## **COLVIN SUBDIVISION**

APPLICATION NUMBER 6 DATE July 5, 2012

REQUEST Subdivision

# DETAIL SITE PLAN

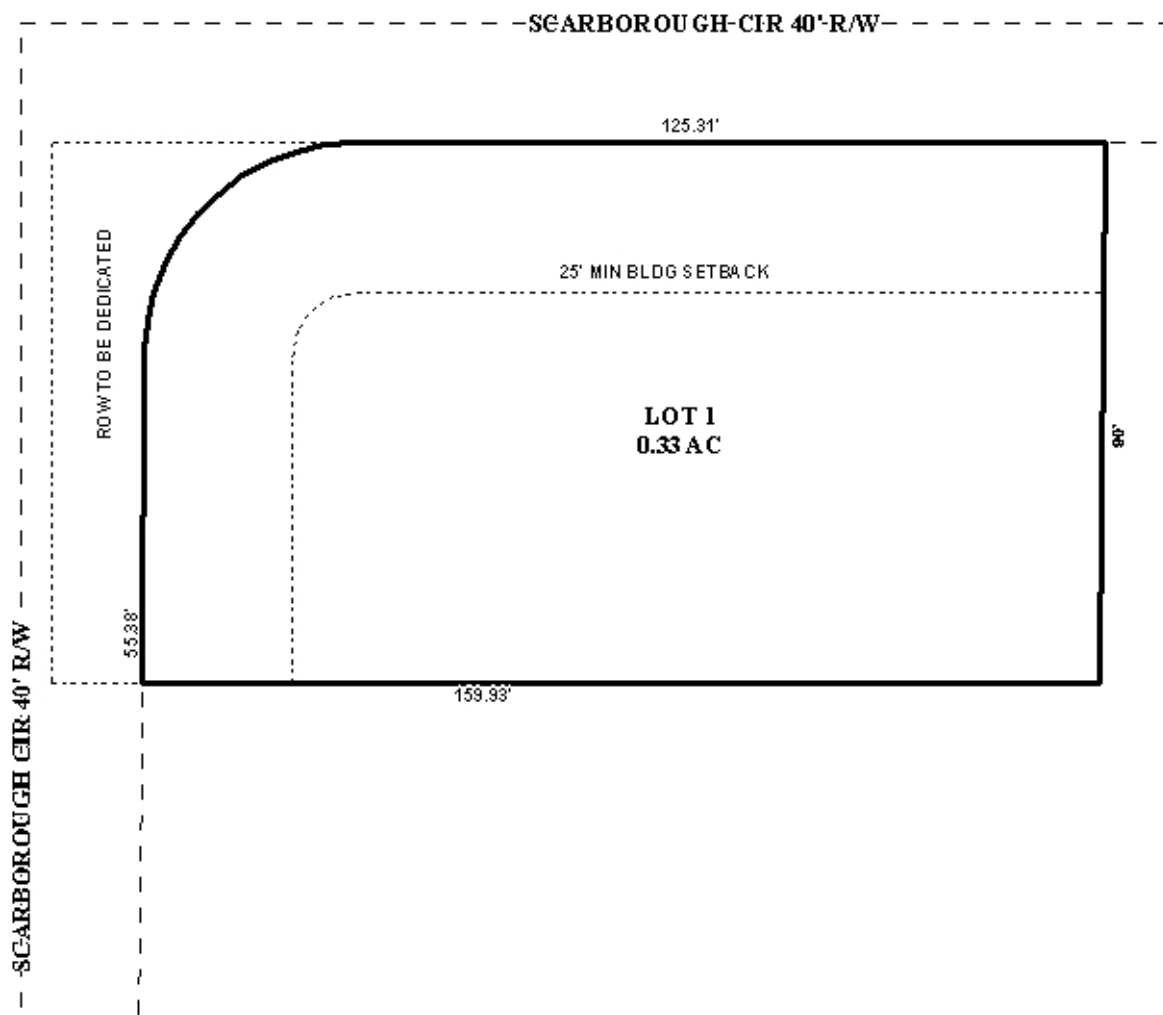
Engineering Comments: The following comments should be addressed prior to acceptance and signature by the City Engineer: 1. Add a signature block for the Planning Commission and Traffic Engineer. 2. Add the curve data for the northwest corner of the property. 3. If topographic contours are to remain they should be labeled. 4. Correct the spelling of the street names in the vicinity map. 5. Provide all other information required for a Final Plat review.

The proposed lot, as depicted, meets the minimum size and frontage requirements as regulated by the Subdivision Regulations. The lot area size is depicted on the plat in acres, and this should be retained with the inclusion of square feet on the Final Plat, if approved. The 25-foot minimum building setback line is depicted, however, the site is located on a substandard width street; therefore, dedication would be required.

Given that the Scarborough Circle West frontage would only provide approximately 45-feet in width, one curb cut to Scarborough Circle would seem to be appropriate. As such, a note should be placed on the Final Plat, if approved, denying the lot access to Scarborough Circle West and limiting the lot to one curb cut to Scarborough Circle, with the size, design, and exact location of the curb cut to be approved by Traffic Engineering and conform to AASHTO standards.

On the preliminary plat, the note stating “any lots developed commercially and adjoin residentially developed property must provide a buffer, in compliance with Section V. A. 8. of the Subdivision Regulations” should be removed, since this property is zoned R-1, Single-Family Residential.

- 1) labeling of the lot size, in square feet and acres, or provision of a table on the Final Plat with the same information;
- 2) dedication to provide 30-feet right-of-way from the centerline of Scarborough Circle and Scarborough Circle West;

- 3) compliance with Section V.B.16. of the Subdivision Regulations regarding the dedication of curb radii at the corner of Scarborough Circle and Scarborough Circle West, with the size and design to be approved by Traffic Engineering/Engineering and conform to AASHTO standards;

- 4) placement of a note on the Final Plat stating the lot is limited to one curb cut to Scarborough Circle with the size, design, and exact location of the curb cut to be approved by Traffic Engineering and conform to AASHTO standards;

- 5) compliance with Engineering comments: “The following comments should be addressed prior to acceptance and signature by the City Engineer: 1. Add a signature block for the Planning Commission and Traffic Engineer. 2. Add the curve data for the northwest corner of the property. 3. If topographic contours are to remain they should be labeled. 4. Correct the spelling of the street names in the vicinity map. 5. Provide all other information required for a Final Plat review.”;

- 7) placement of a note on the Final Plat stating that development of the site must be undertaken in compliance with all local, state and Federal regulations regarding endangered, threatened or otherwise protected species.
